**SERVICE BULLETIN**

**N° 139-618**

**ATA 71 – TUNNEL ASSY RETROMOD**

Leonardo Helicopter Division has developed this Service Bulletin in order to perform the installation of the tunnel assy and firewalls retromod P/N 3G7130P01611 and the tunnel assy and firewalls retromod P/N 3G7130P01811.

**Figure 1**

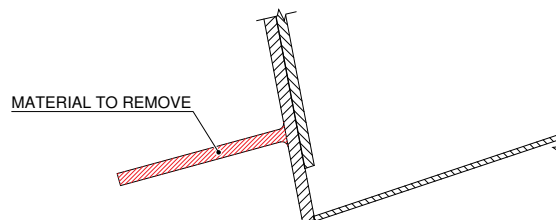
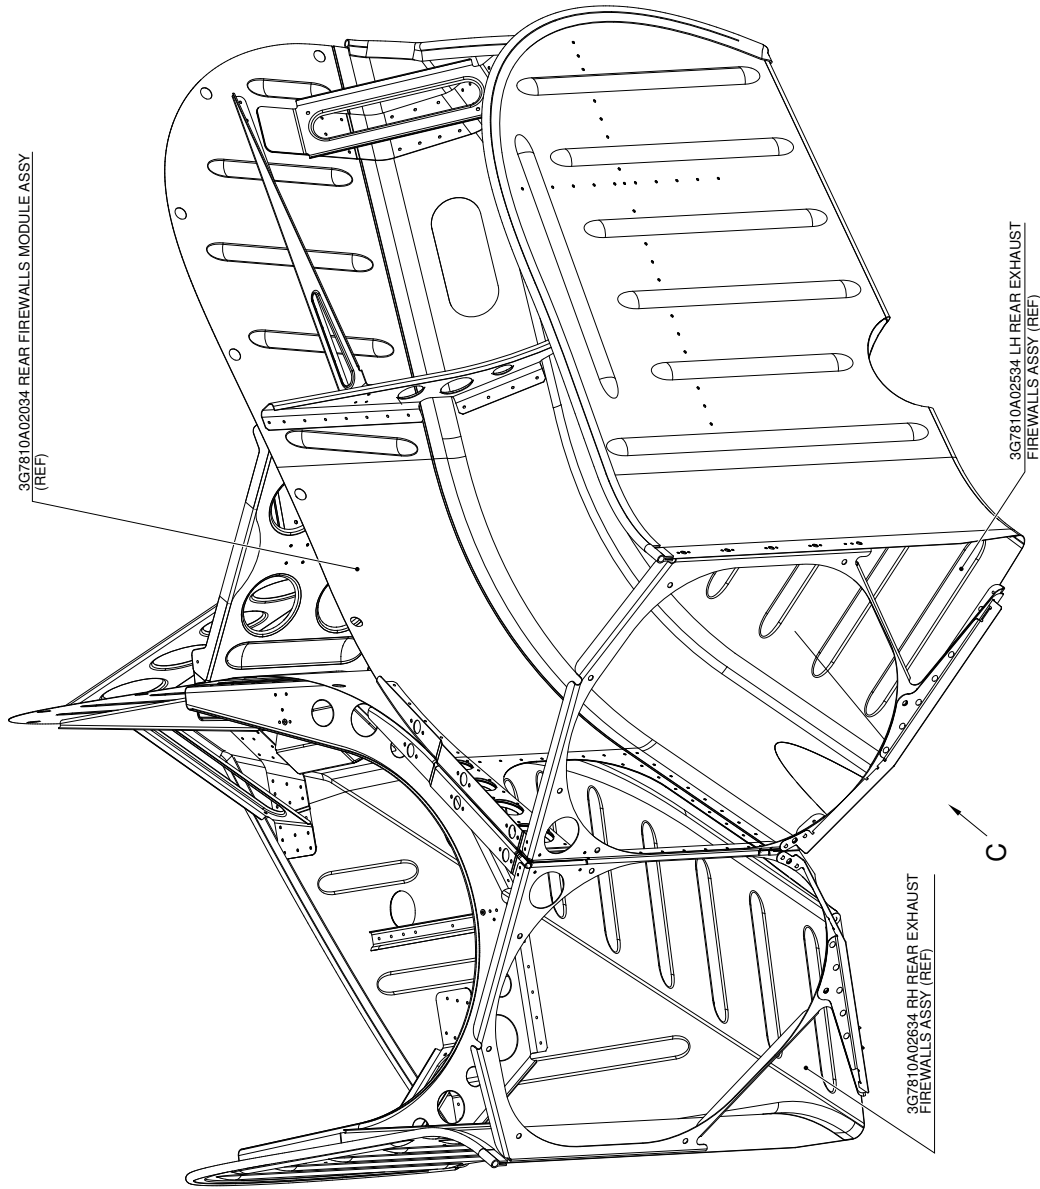
4. With reference to Figures 1 thru 3, perform the rear firewalls module retromod as described in the following procedure:
  - 4.1 With reference to Figure 1 Section B-B, remove material from LH and RH rear exhaust firewalls assemblies as indicated.

- 4.7 With reference to Figure 1, remark the reworked rear firewalls module assy as P/N 3G7810P02231.
5. In accordance with AMP DM 39-C-78-10-03-00A-520A-A, remove the left cover from the helicopter. Retain the fixing hardware for later reuse.

**Figure 2**

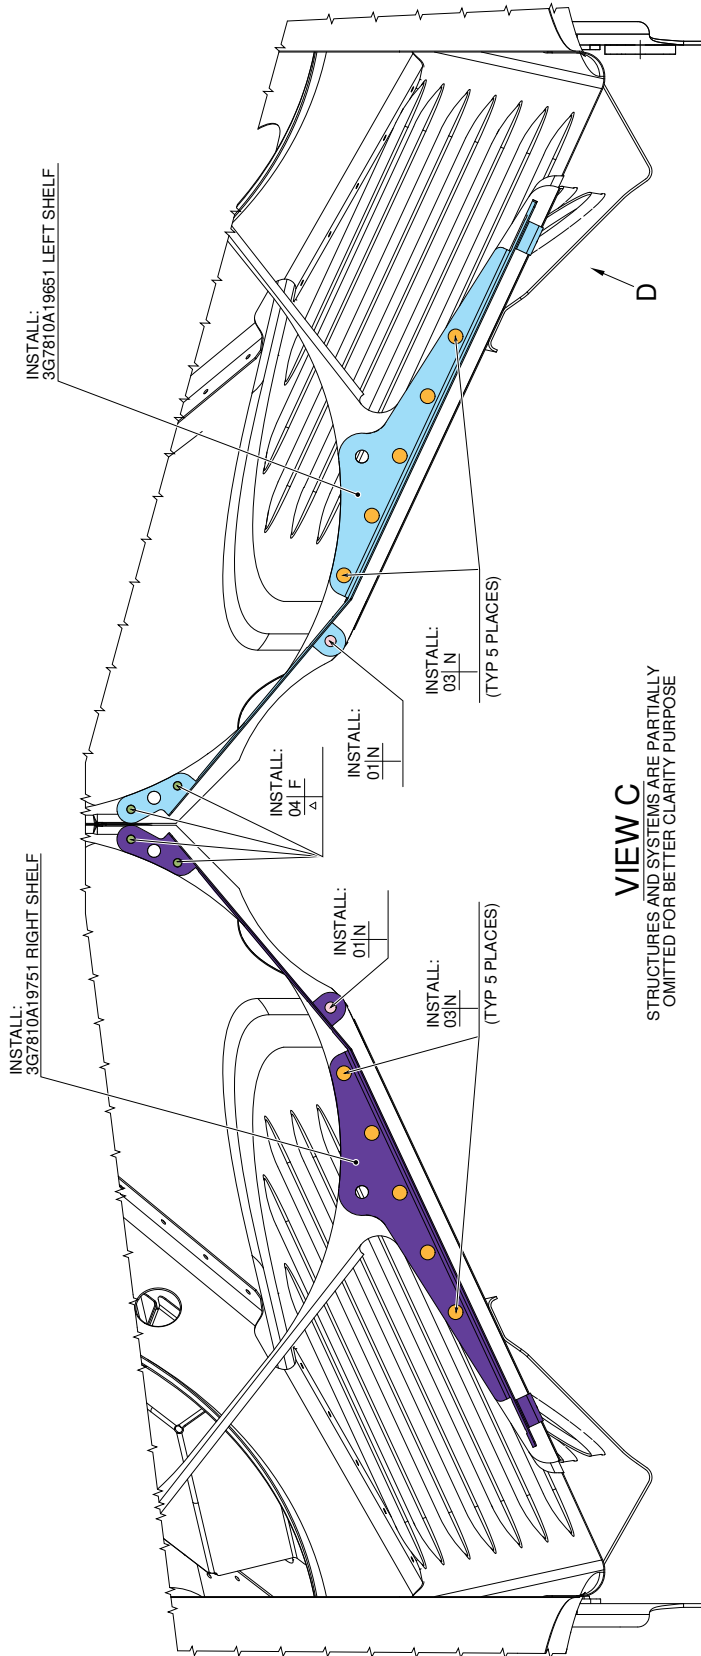
- 4.2 With reference to Figure 3 View D, drill out the existing rivet P/N MS20615-4M3R in the indicated positions on LH and RH sides.
  - 4.3 With reference to Figure 2 and Figure 3 View C, temporarily locate left shelf P/N 3G7810A19651 on LH rear exhaust firewalls assy P/N 3G7810A02534 and countermark the position of n°8 rivets that must be installed. Drill n°8 pilot holes on LH rear exhaust firewalls assy.

**Figure 3**

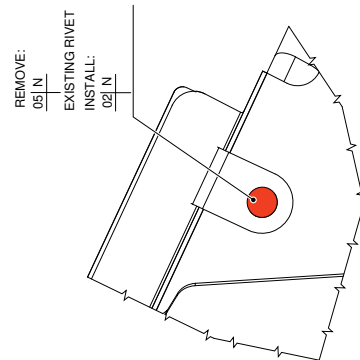
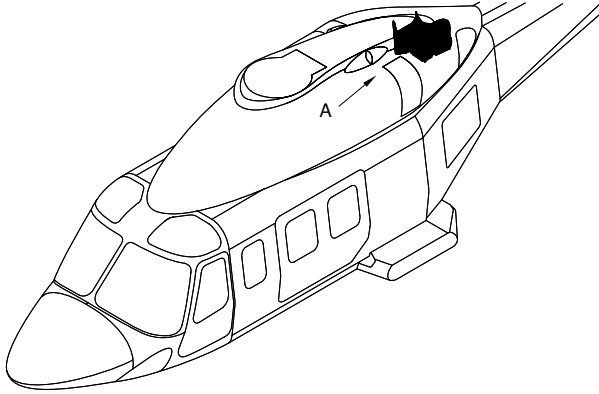
- 4.4 With reference Figure 3, install left shelf P/N 3G7810A19651 by means of n°5 rivets P/N MS20615-4M4R, n°2 rivets P/N NAS1200-3-4, rivet P/N MS20615-4M4 and rivet P/N MS20615-3M3R.

- 4.6 With reference Figure 3, install right shelf P/N 3G7810A19751 by means of n°5 rivets P/N MS20615-4M4R, n°2 rivets P/N NAS1200-3-4, rivet P/N MS20615-4M4 and rivet P/N MS20615-3M3R.

**Figure 5**

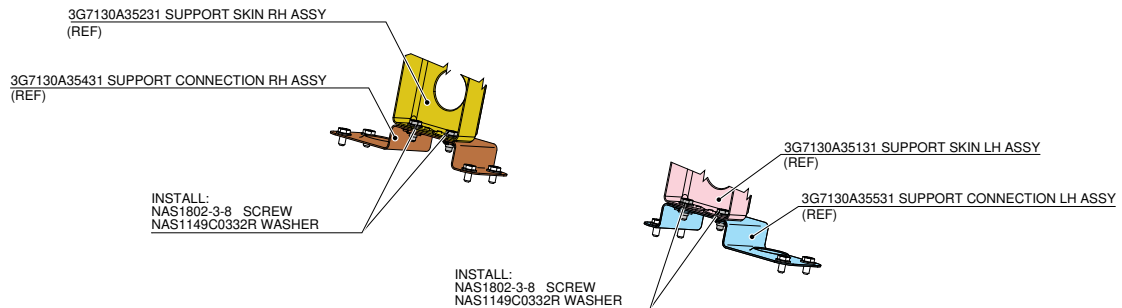
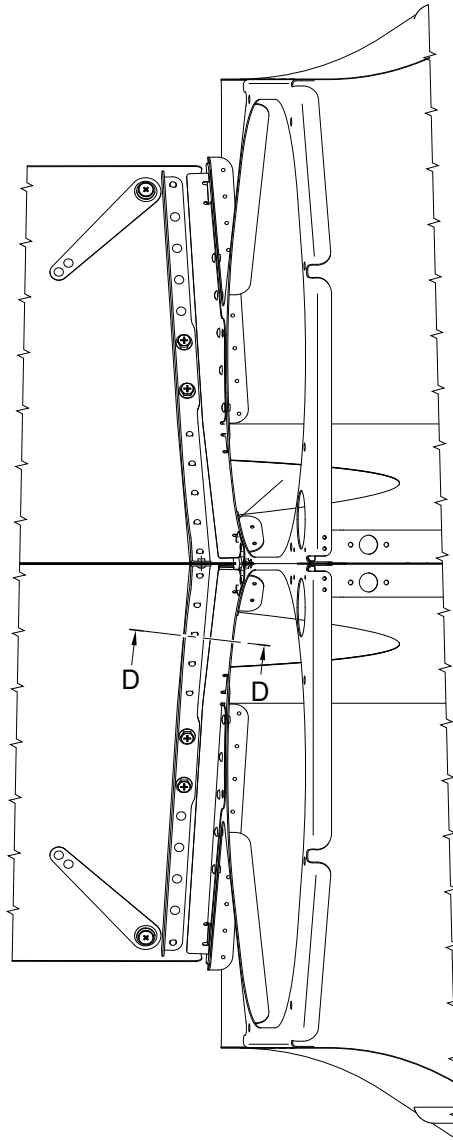
9. With reference to Figure 5, remove and discard the tunnel assy P/N 3G7130A13433 or P/N 3G7130A13434 or P/N 3G7130P00131 from the helicopter, unlocking the related turn locks.
10. With reference to Figure 5 View B, install support connection RH assy P/N 3G7130A35431 by means of n°4 screws P/N NAS1802-3-6 and n°4 washers P/N NAS1149C0332R.
11. With reference to Figure 5 View B, install support connection LH assy P/N 3G7130A35531 by means of n°4 screws P/N NAS1802-3-6 and n°4 washers P/N NAS1149C0332R.
12. With reference to Figure 5 View C, install support skin RH assy P/N 3G7130A35231 by means of n°2 screws P/N NAS1802-3-8 and n°2 washers P/N NAS1149C0332R.
13. With reference to Figure 5 View C, install support skin LH assy P/N 3G7130A35131 by means of n°2 screws P/N NAS1802-3-8 and n°2 washers P/N NAS1149C0332R.

14. With reference to Figure 5 View B, bond the gasket P/N 3G7130A26152 to the tunnel assy at STA 7385 using adhesive RTV 730.
15. With reference to Figure 5 View B, install tunnel assy P/N 3G7130A13435 by means of related turn locks, n°4 screws P/N NAS1802-3-8 and n°4 washers P/N NAS1149C0332R.
16. With reference to Figures 13 and 14, check the clearances between tunnel assy and tail rotor shaft as described in the following procedure:

**Figure 7**

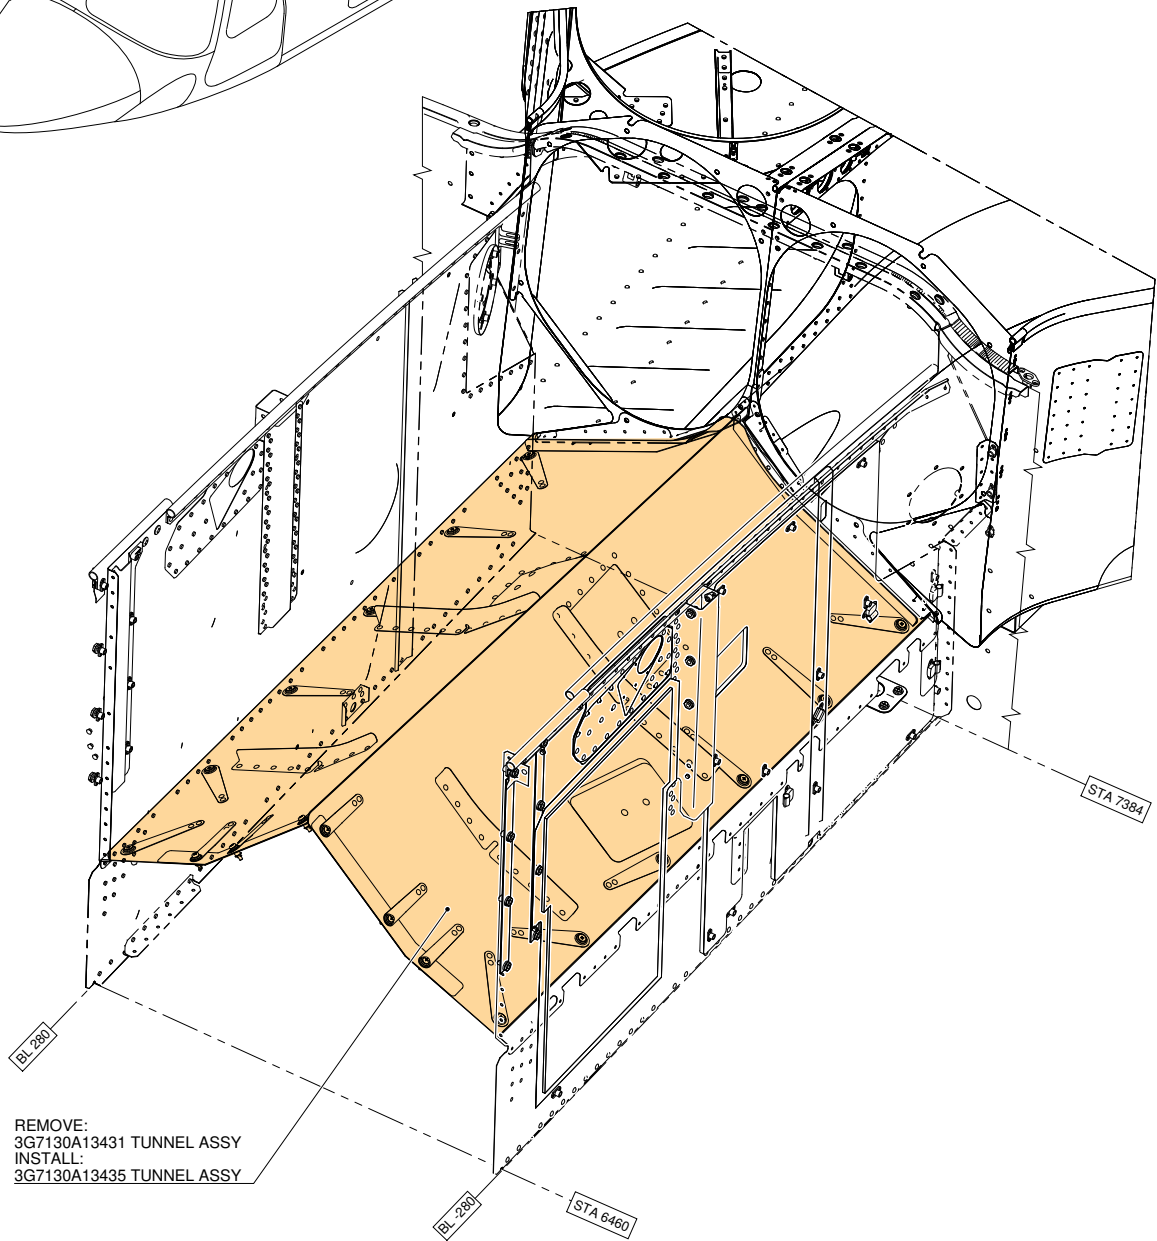
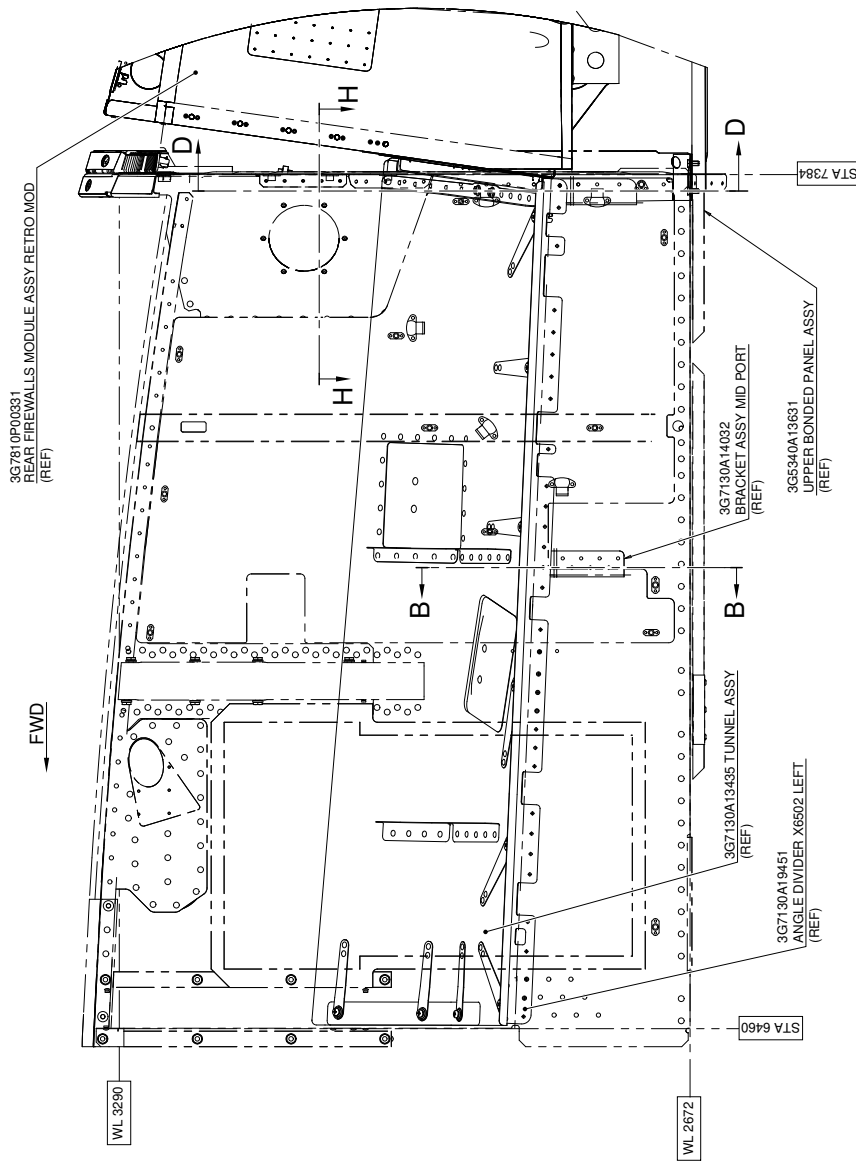
8. In accordance with AMP DM 39-C-78-10-06-00A-520A-A, remove the right exhaust duct from the helicopter. Retain the fixing hardware for later reuse.
9. With reference to Figure 7, remove and discard the tunnel assy P/N 3G7130A13431 or P/N 3G7106P10031 from the helicopter, unlocking the related turn locks.

**Figure 8**

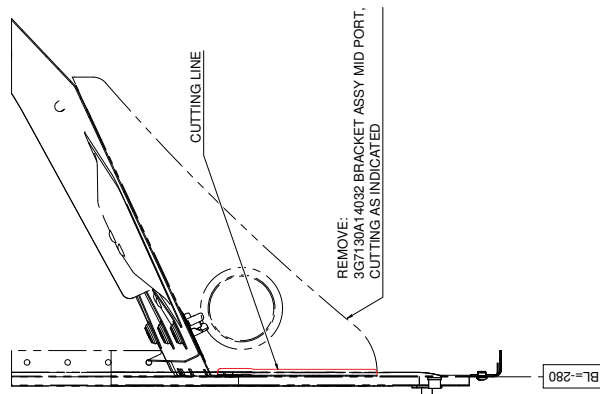
11. With reference to Figure 8 Section B-B, cut along cutting line shown to remove bracket assy mid port 3G7130A14032.
12. Repeat step 11 to remove bracket assy aft port P/N 3G7130A14231, bracket assy mid stbd P/N 3G7130A14132 and bracket assy aft stbd P/N 3G7310A14331.

**Figure 9**

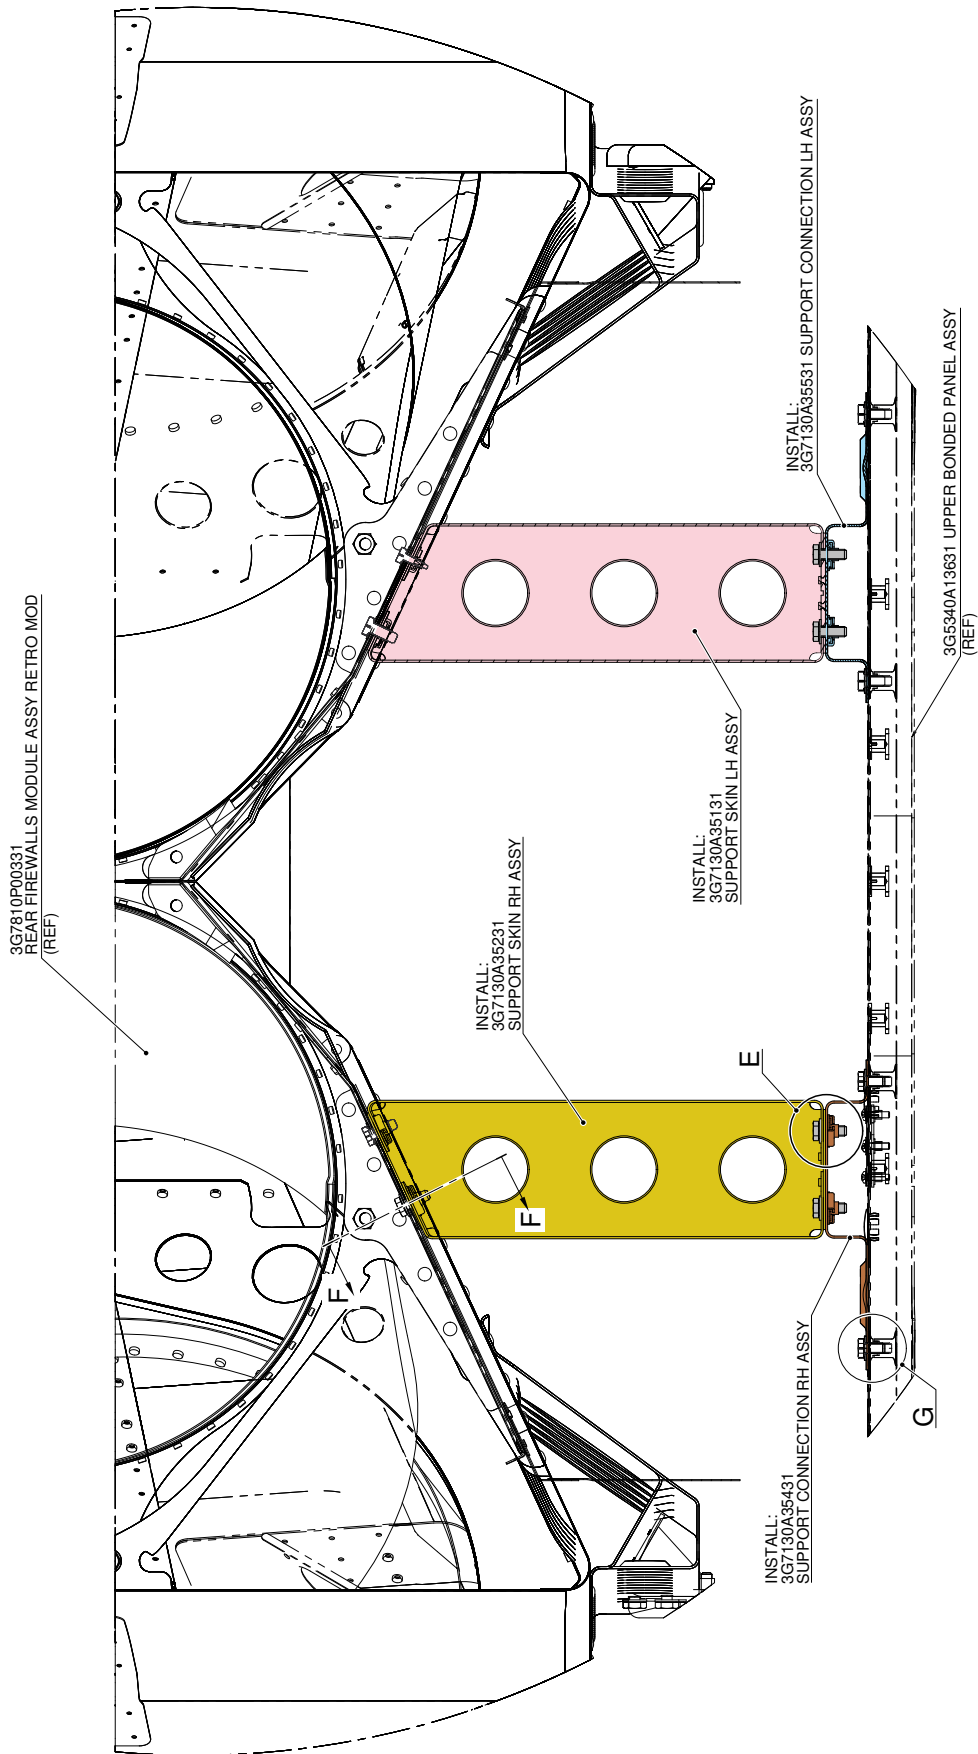
10. With reference to Figure 9, remove and discard n°12 anchor nuts P/N A242ARD.

13. With reference to Figure 9, install plate LH assy P/N 3G7130A36331 and plate RH assy P/N 3G7130A36431 by means of n°80 rivets P/N NAS1200-3-3.
14. With reference to Figure 10 and Figure 11 Detail G, install support connection RH assy P/N 3G7130A35431 by means of n°4 screws P/N NAS1802-3-8 and n°4 washers P/N NAS1149C0332R.

**Figure 10**

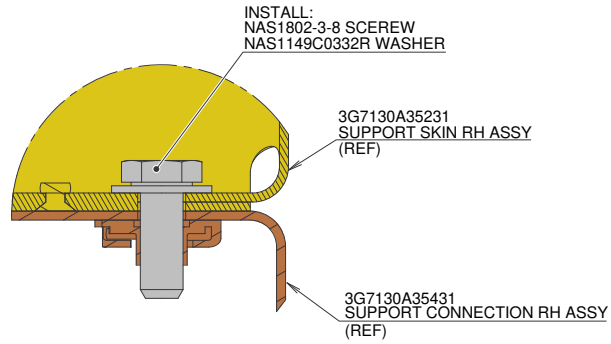
15. With reference to Figure 10 and Figure 11 Detail G, install support connection LH assy P/N 3G7130A35531 by means of n°4 screws P/N NAS1802-3-8 and n°4 washers P/N NAS1149C0332R.

16. With reference to Figure 10 and Figure 11 Detail E, install support skin RH assy P/N 3G7130A35231 by means of n°2 screws P/N NAS1802-3-8 and n°2 washers P/N NAS1149C0332R.

17. With reference Figure 10 and Figure 11 Detail E, install support skin LH assy P/N 3G7130A35131 by means of n°2 screws P/N NAS1802-3-8 and n°2 washers P/N NAS1149C0332R.

**Figure 11**

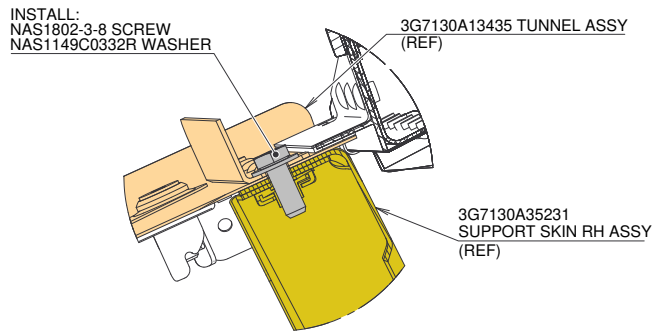
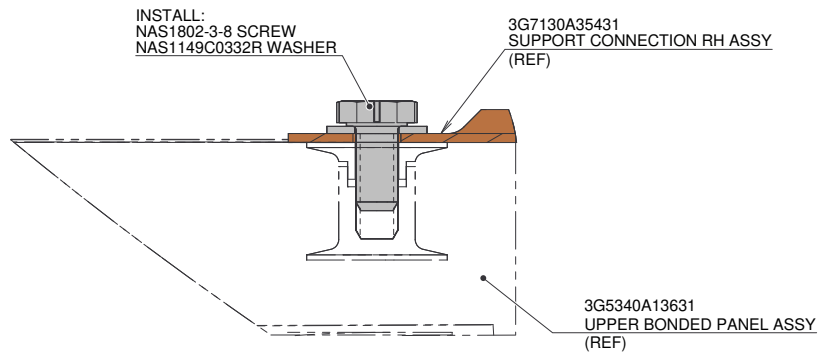
18. With reference to Figure 5 View B, bond the gasket P/N 3G7130A26152 to the tunnel assy at STA 7385 using adhesive RTV 730.
19. With reference to Figures 7, 10 and Figure 11 Section F-F, install tunnel assy P/N 3G7130A13435 by means of related turn locks, n°4 screws P/N NAS1802-3-8 and n°4 washers P/N NAS1149C0332R.
20. With reference to Figures 13 and 14, check the clearances between tunnel assy and tail rotor drive as described in the following procedure:
